COPPER CHASE AT STERLING RANCH FINAL PLAT

LETTER OF INTENT

REVISED MAY 2023

V_1 LOI.pdf Markup Summary 6-28-2023

DISTRICTS/ENTITIES SERVING THE PROPERTY:

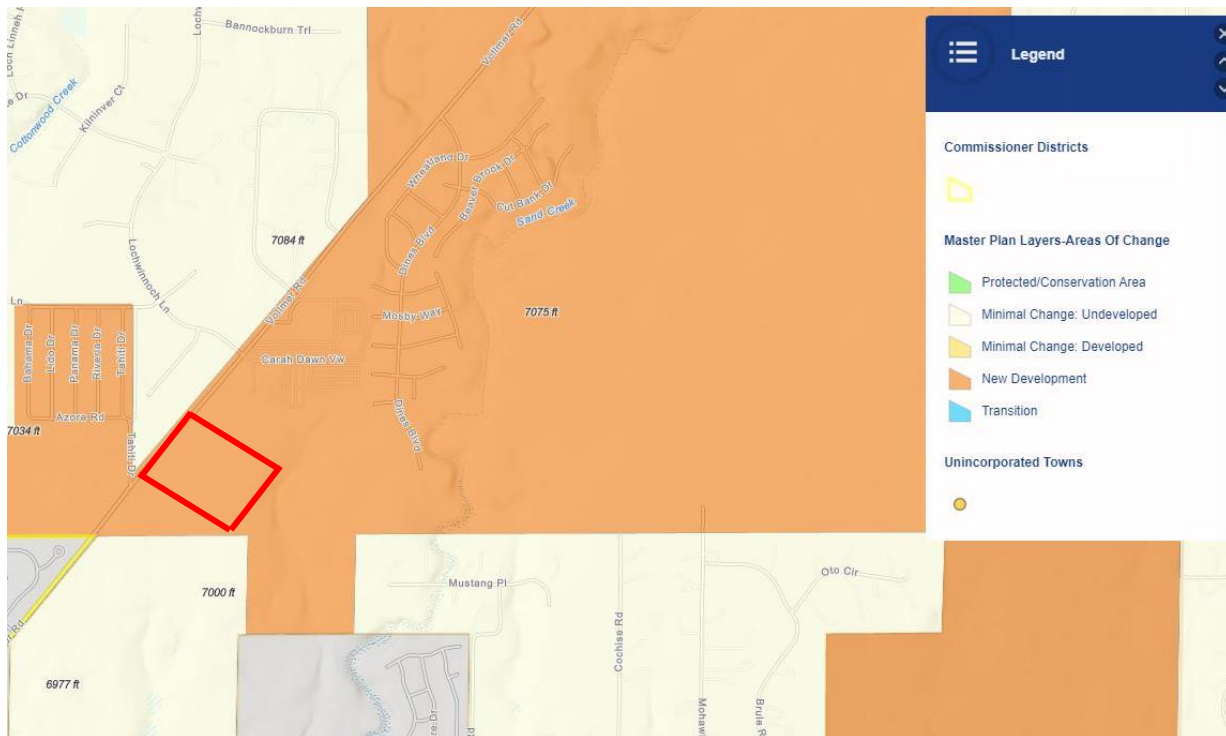
Revised
↓
FAWWA
